Notice of Modification

Project approval 09_0203 for the West Wallsend Continued Operations Project, granted by the delegate of the Minister for Planning and Infrastructure on 25 January 2012.

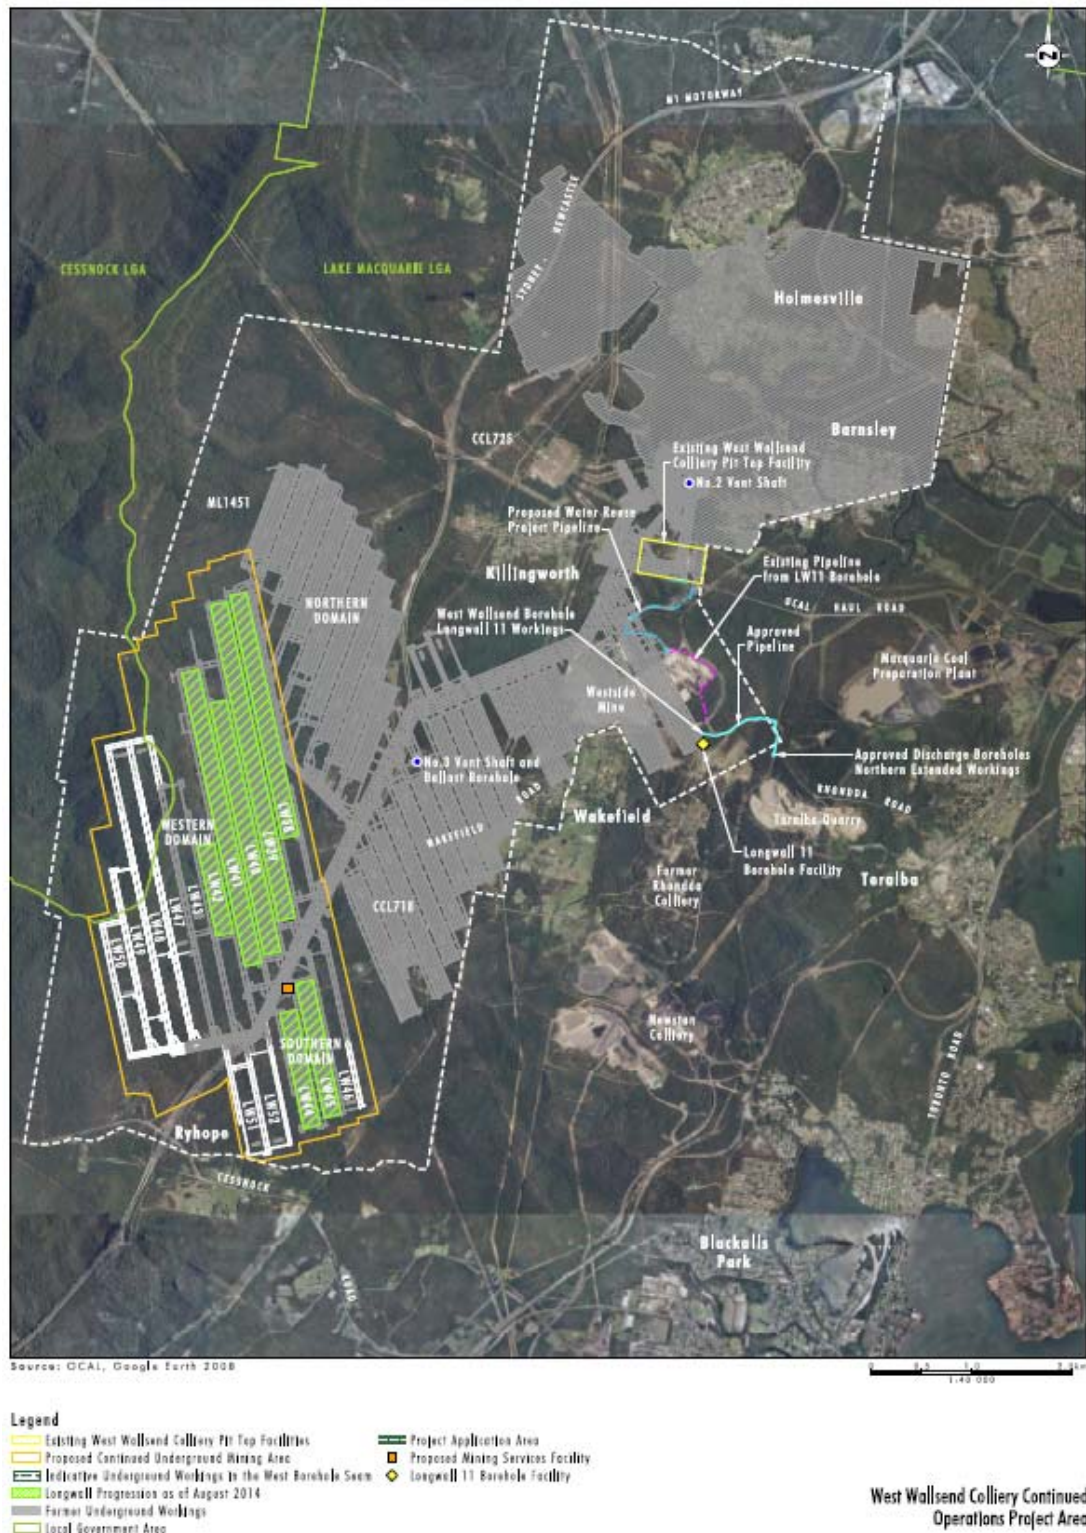
10. Delete the second figure in Appendix 2 and replace with:
